PROPOSED TECHNICAL SPECIFICATION (TS) CHANGE SEQUOYAH NUCLEAR PLANT (SQN) UNITS 1 AND 2

(TVA-SQN-TS-95-11)

LIST OF AFFECTED PAGES

SEQUOYAH - UNIT 1	TABLE 2.2-1 (Continued)				-	
		REACTOR TRIP SYSTEM INSTRUMENTATION TRIP SETPOINTS				
	FUNCTIONAL UNIT		TRIP SETPOINT ALLOWABLE VALUES

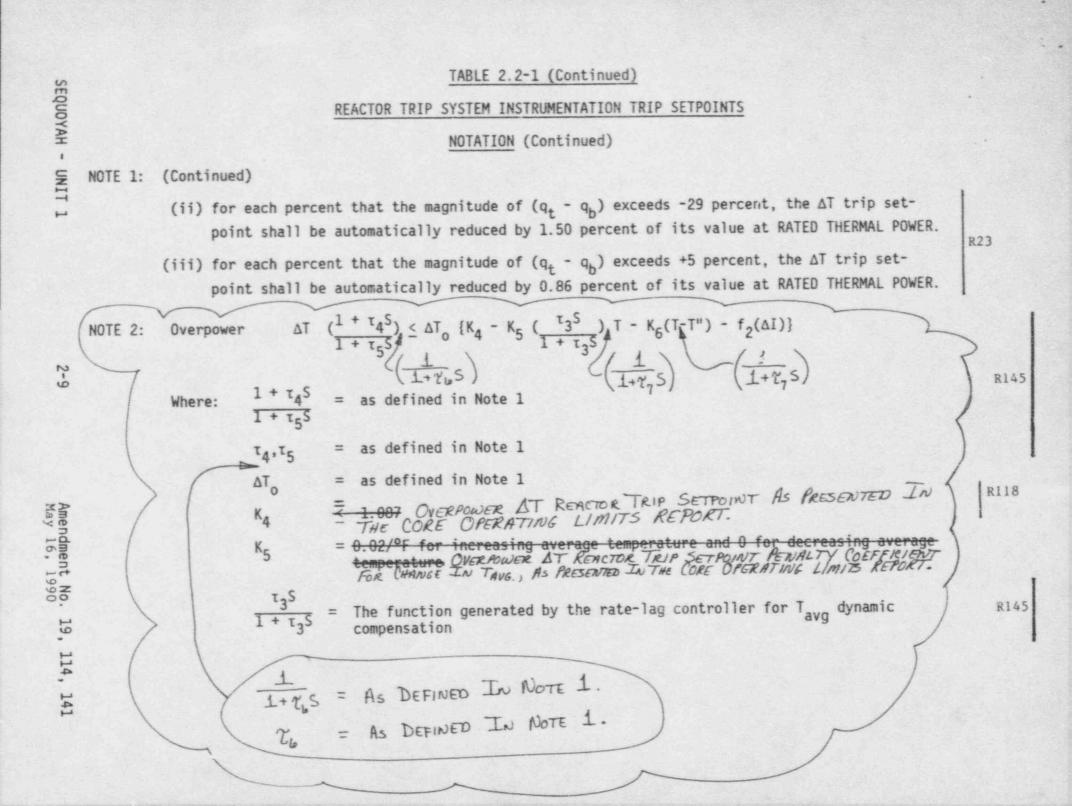
25.	Power Range Neutron Flux - (P-9) - Blocks Reactor Trip for Turbine Trip Below 50% Rated Power (1) (1+T ₀ S) NO	< 50% of RATED THERMAL POWER	< 52.4% of RATED R145 THERMAL POWER		
Amendment No. 19, 114, 141 MAY 1 6 1990	") - f ₁ (Δ1)) R145 Her for ΔΙ, As PRESENTED IN THE THE FOR ΔΙ, TA PRESENTED IN THE THOINT AS PRESENTED IN THE ATT S REPORT. TA PRESENTED IN THE DR ΔT, AS PRESENTED IN THE

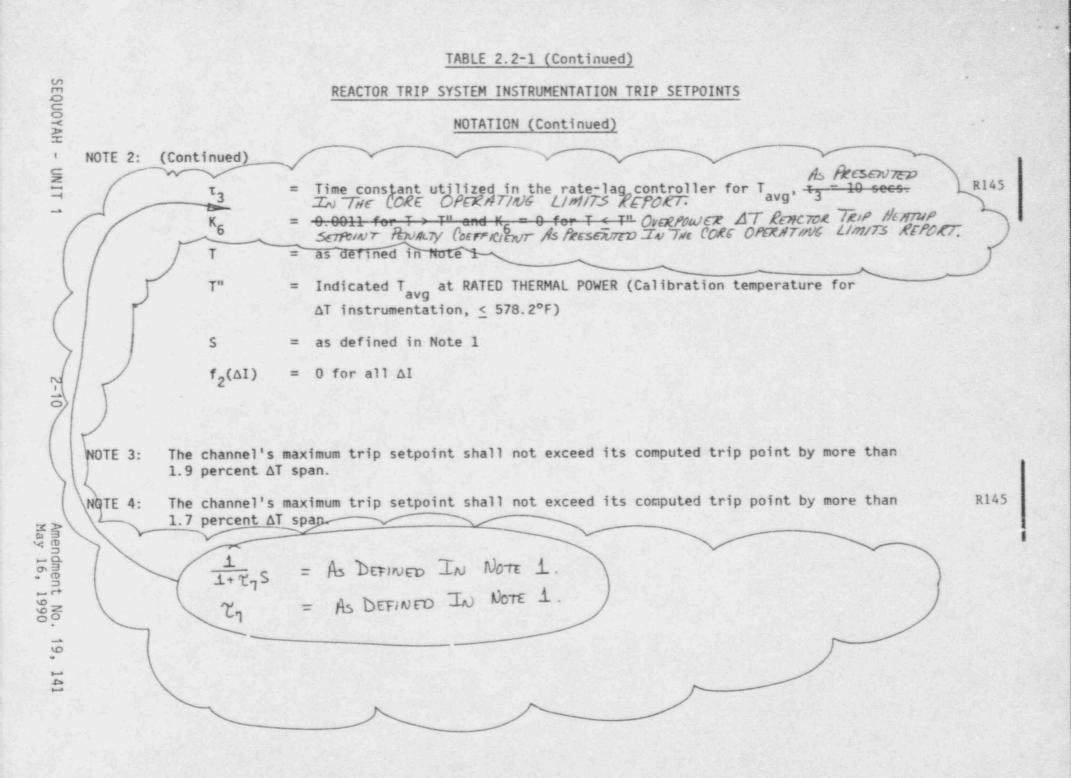
SEQUOYAH TABLE 2.2-1 (Continued) REACTOR TRIP SYSTEM INSTRUMENTATION TRIP SETPOINTS NOTATION (Continued) . UNIT NOTE 1: (Continued) 1 + T.S -= The function generated by the lead-lag controller for T avo dynamic compensation 1 + 1,5 R145 Time constants utilized in the lead-lag controller for T avg, As PRESENTED IN THE. T1, & T2 Average temperature °F P R145 < 578.2°F (Nominal Tavo at RATED THERMAL POWER) Q. 00055 OVERTEMPERATURE AT REACTOR TRIP DEPRESSURIZATION SETPOINT PENALTY K3 N DEFFICIENT AS PRESENTED IN THE CORE OPERATING LIMITS REPORT. œ Pressurizer pressure, psid p: 2235 psig (Nominal RCS operating pressure) = Laplace transform operator (sec⁻¹) S and $f_1(\Delta I)$ is a function of the indicated difference between top and bottom detectors of the power-range nuclear ion chambers; with gains to be selected based on measured instrument response during plant startup tests such that: (i) for $q_t - q_b$ between - 29 percent and + 5 percent $f_1(\Delta I) = 0$ (where q_t and q_b are percent RATED THERMAL POWER in the top and bottom haives of the core respectively, MAY Amendment and q. + q. is total THERMAL POWER in percent of RAIED THERMAL POWER) 1+275 = LAG COMPENSATOR ON MEASURED TAVE. = TIME CONSTANT UTILIZED IN THE MEASURED TAVE. LAG COMPENSATOR, AS PRESENTED IN THE CORE OPERATING LIMITS REPORT. -0 27 -P -
